**BEFORE THE INDEPENDENT HEARING COMMISSIONERS
IN CHRISTCHURCH**

IN THE MATTER of the hearing of submissions on Plan Change 14
(Housing and Business Choice) to the Christchurch
District Plan

JOINT STATEMENT OF URBAN DESIGN AND ARCHITECTURE.

5th October 2023

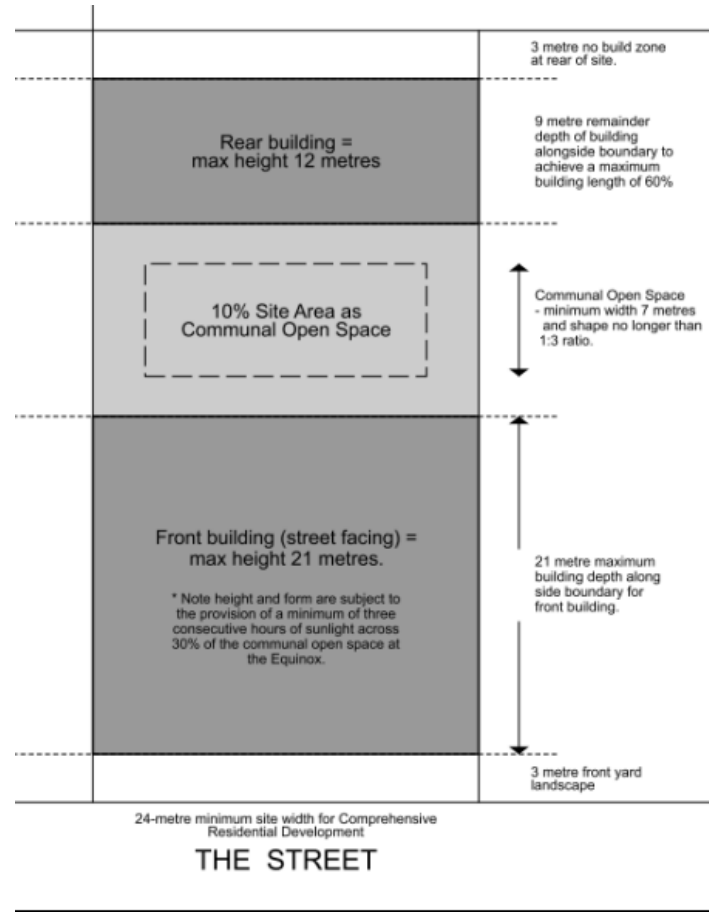
Issue	Agreed Position	Disagreements or reservations, with reasons
KO: CCMUZ – height to 39m [para 3.100]	NW and JC agreed that there should be a step change in height down from the Central City Zone to the Central City Mixed Use Zone and the Central City Mixed Use Zone (South Frame).	Disagreement between NW recommended 32m height and JC recommended 39m to align MU with Residential High Density. It was agreed that JC had taken a more high-level approach across zones, whereas NW has considered strategic direction and specific block and contextual issues

i.e. narrower street widths and larger site sizes etc.
KO: TCZ – street wall height and upper level building setback	Agreed that proposed street wall height and then setback is required.	.
KO: CCMUZ(SF) - height 21/22m	<p>Agreed that a lower height is appropriate for CCMUZ (SF), especially given the removal of the operative 13-metre height overlay over High Street (between Lichfield and St Asaph Streets as illustrated in green outline below). Minor disagreement with the height of 21-metres recommended by NW (or 22m as sought by JC).</p>  <p><i>Figure 1 – Map of operative 13-metre height along High Street (green line) which is to be removed in PC14. Note CCMUZ(SF) zone</i></p>

<p><i>provisions will be in place for these two blocks which include a number of special heritage items and settings.</i></p>	
<p>KO MUZ – Sydenham</p>	<p>JC issue is how to enable this small lot industrial area which is largely intact to transition to residential. JC considers that the residential enablement should focus on the part of this zone that is closest to the City Centre and has higher amenity. NW tabled lot size plans that illustrate contiguously owned sites comprising upward of 2,000sqm. West of Durham Street, a number of sites between 5,000sqm – 2 hectares exist.</p> <p>However, both agree that the Comprehensive Housing Precinct (15.2.3.2 / 15.10.2.9 / 15.14.3.40) should be more focused. JC and NW agree that the Precinct in Sydenham be consolidated between Montreal Street to Hawdon Street. NW also supports JC’s addition of the section (see solid red outline) on the west side of Montreal Street to better interface with the existing residential activity here.</p>

Fig 3 – cross section of Riccarton Road (east west) illustrating the added shading at the Equinox between a 6m upper level setback and a 45-degree setback and the council recommended height of 32-metres. Also illustrated is KO's 52metre recommendation.

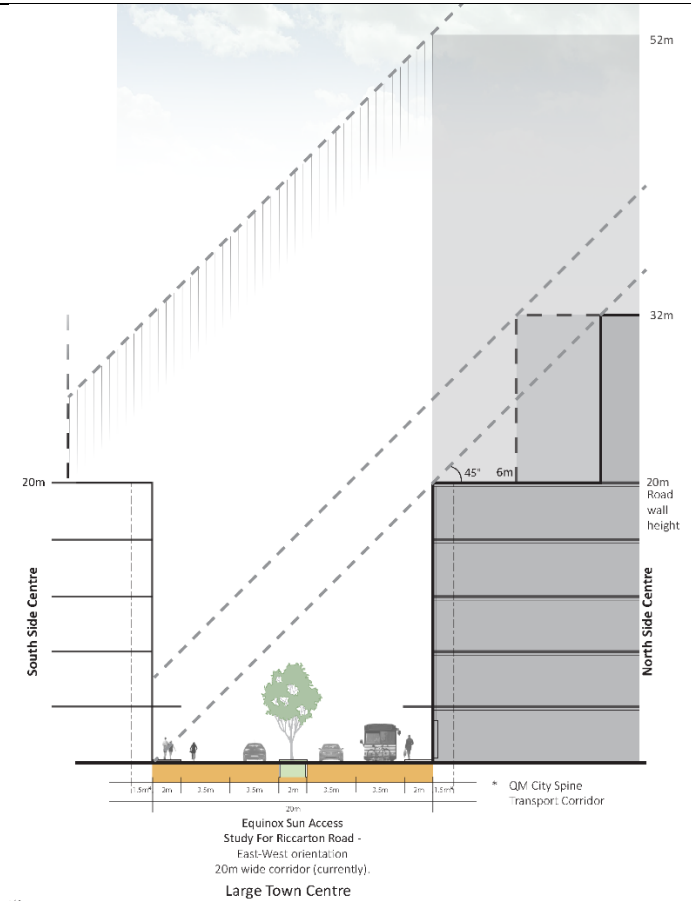
Issue	Agreed Position	Disagreements or reservations, with reasons
KO: Centre hierarchy – changing status of Riccarton, Papanui and Hornby from Town Centre Zone to Metropolitan Centre Zone. [para 3.150]	NW and JC agreed that this is primarily a planning issue and that urban design matters such as height and road wall / set back flow from the resolved centre status.	NW maintains a 20m road wall height and 45-degree (close to the lower equinox sun angle in Ōtautahi, Christchurch) upper-level setback is recommended to provide for a pleasant street environment to encourage modal shift towards active modes such as walking, cycling and scooting, as well as encourage uptake (noting cooler climate and lower sun angles in Ōtautahi) of the proposed Light Rail on the east-west City Spine Transport Corridor between Hornby, Riccarton, Central City in particular.

JC considers that sunlight access to the footpath is a minor issue in large commercial centres that is readily

outweighed by the benefits of greater intensity of activity.
--	--	--
